ADDRESS: 1108 S FRONT ST

Proposal: Legalize addition and roof deck

Review Requested: Final Approval

OVERVIEW: Between December 2023 and March 2024, a significant addition was constructed at the rear of 1108 S. Front Street without a building permit or the Historical Commission's review or approval. The Historical Commission did approve interior demolition and make-safe permit applications in August and December 2023, respectively, but those permits did not cover the new construction. When a Historical Commission staff member visited the site, he saw that the unpermitted addition was under construction despite a Stop Work Order issued by the Department of Licenses and Inspections on 9 February 2024. A similar application for legalization was reviewed by the Architectural Committee and Historical Commission earlier this year, which was denied pursuant to Standards 9 and 10.

1108 S Front St
roof deck

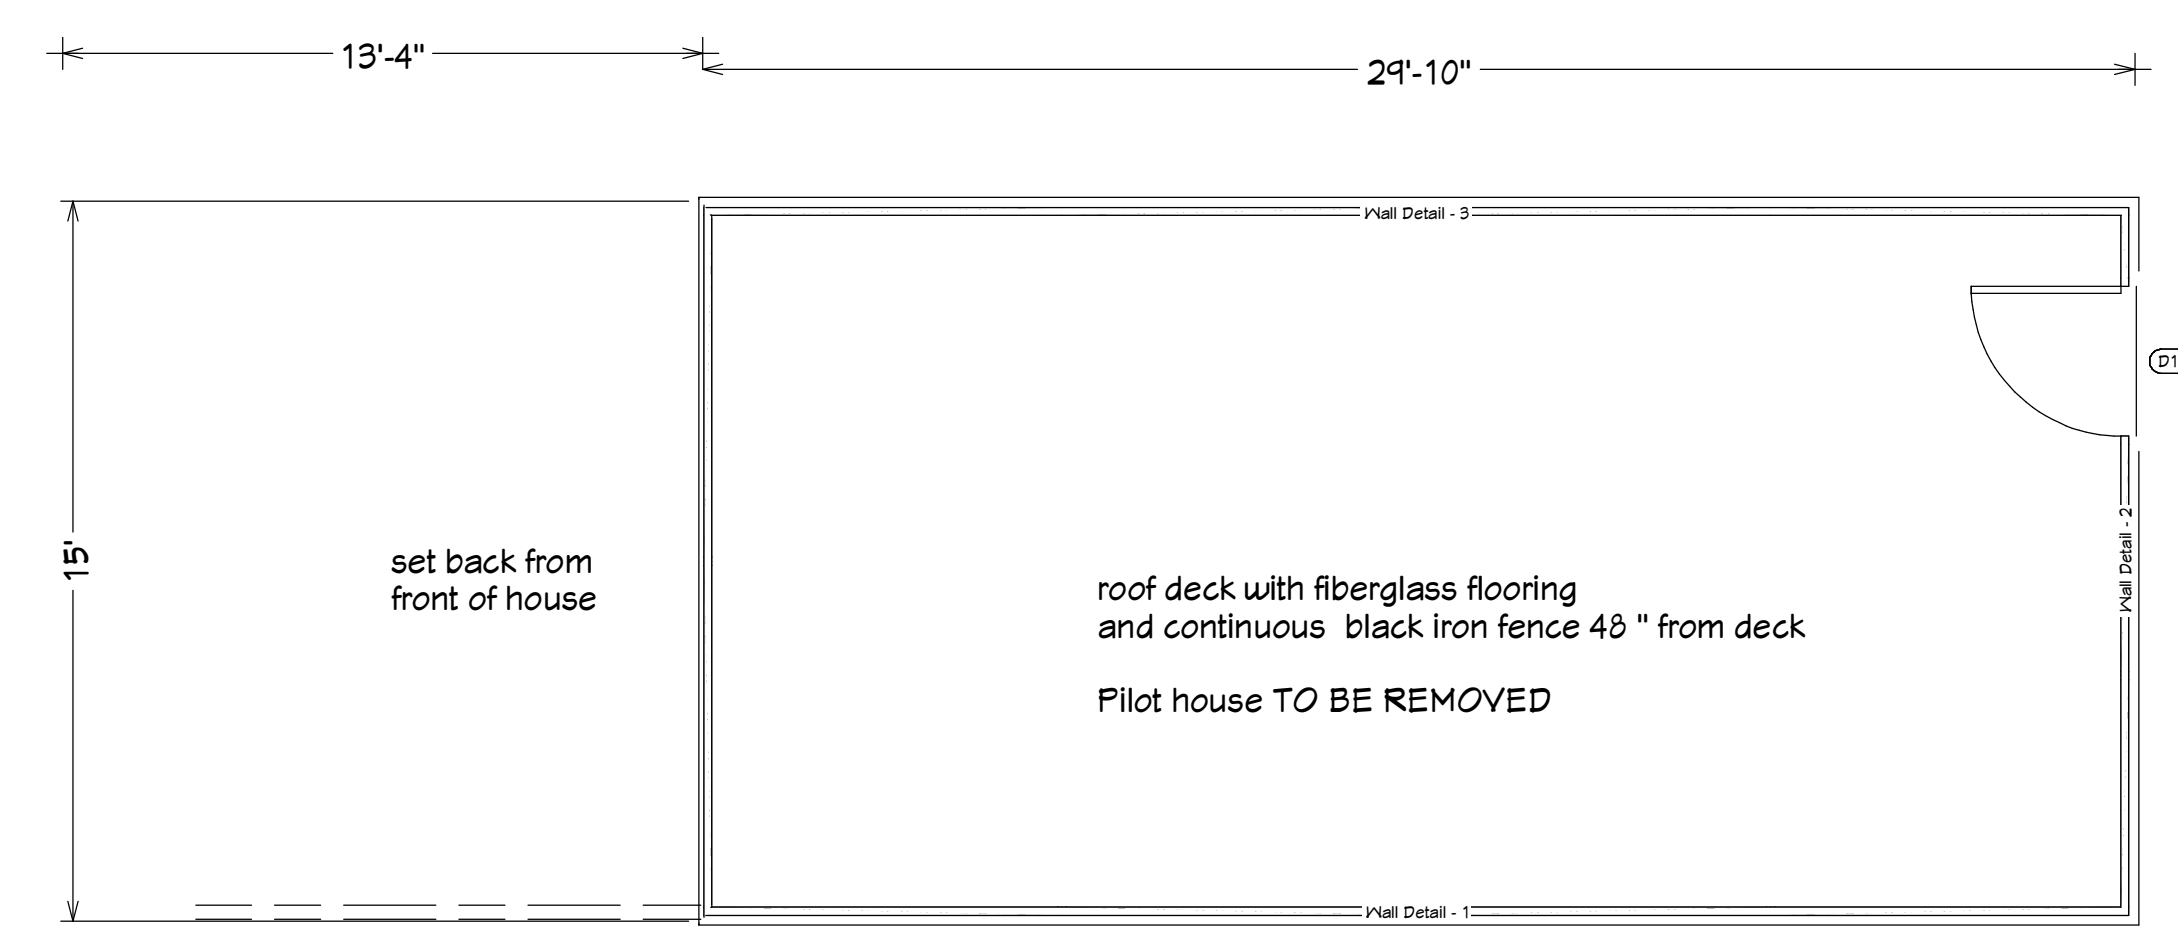
- The rear addition is very large in comparison to the historic structure. Removing the pilot house is an improvement, but the roof deck is still very visible from the public right-of-way and changes the established spatial relationships of the property.
